# SERVICE *No. 926A* BULLETIN

Hartzell Service Bulletin No. 165 E,  
Inspection for Cracks in Certain  
Three Blade "Y" Shank Aluminum  
Propeller Hubs

**SERVICE BULLETIN 165E**  
**CODE: C**

Inspection for Cracks in Certain Three Blade "Y" Shank Aluminum Hubs

Figure 1. Hub Grease Fittings

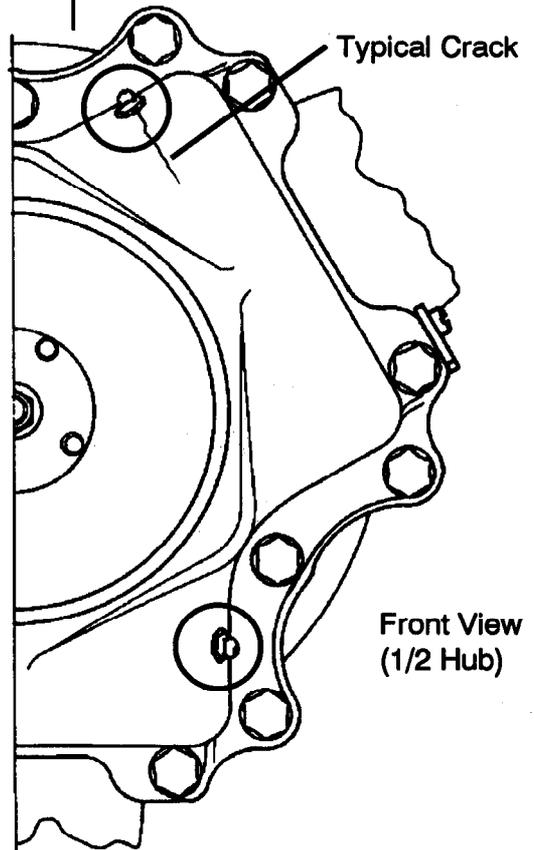
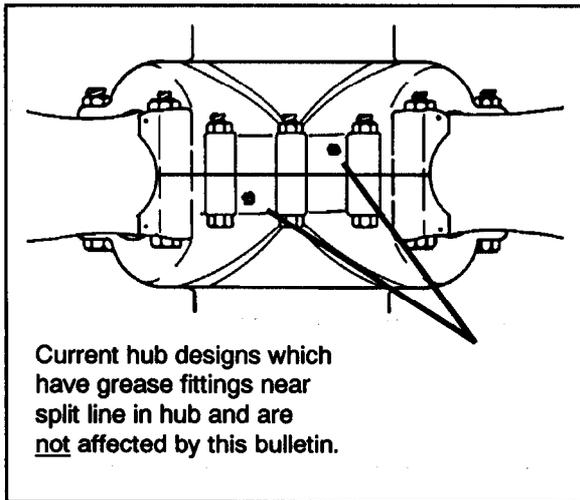
**NOTE:** During 1983, a hub design change relocated the grease fitting holes near the hub parting line (see Figure 1). The earlier-design hubs are listed as affected serial numbers, however, there may be a few hubs listed that are of the later type. Any hub found to be of the current configuration does not require compliance with this Bulletin. Any hub with the old configuration requires compliance.

3. Use 10X magnifying glass and light source to perform careful visual inspection of the hub for hairline cracks in the general vicinity of blade retention bearings, but primarily inspect the grease fitting areas as shown in Figure 1. Perform inspections with grease fittings installed.

**NOTE:** Typically, cracks begin at the grease fitting and propagate perpendicular to blade around the blade arm barrel. Cracks may initiate on either hub half from any of the six (6) grease fittings.

- 2) Scan probe gradually around each of the six grease fittings on the propeller hub. See Figure 1, scan probe in a manner to cross typical crack indications (rather than scanning in strokes that may be parallel to typical crack indications). The center of the probe tip must pass within 1/4 inch of the grease fittings and outward from the fitting as far as practical (up to 2 inches). The initial scanning around the grease fitting should consist of a circle with the probe as close to the grease fitting hole as possible. Perform subsequent scans of concentric circles around the grease fitting with no more than 1/10 inch spacing between circles.

Figure 2. Hub Rework

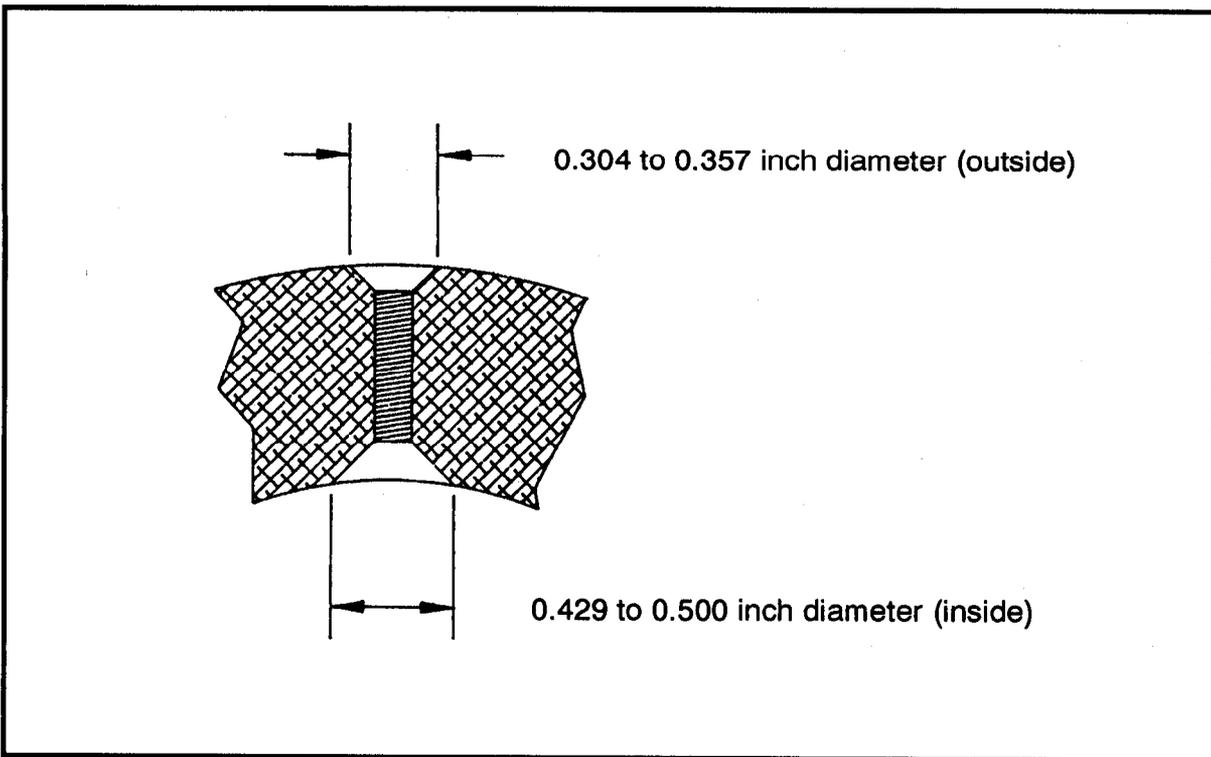
3. Using a 6 fluted, 45° chamfering tool (Hartzell part number 57BST5845), cut a chamfer to 0.429 to 0.500 inch diameter on the inside of the hub at each grease fitting location. Using the same tool, also cut a chamfer 0.304 to 0.357 inch diameter on the external side of each grease fitting hole. See Figure 2.

- b. Check diameter of chamfer using a dial caliper. Hub retirement is required if chamfer exceeds maximum diameter.
4. Polish any sharp edges created by the chamfering tool with 320 grit (or finer) emery cloth or sandpaper.
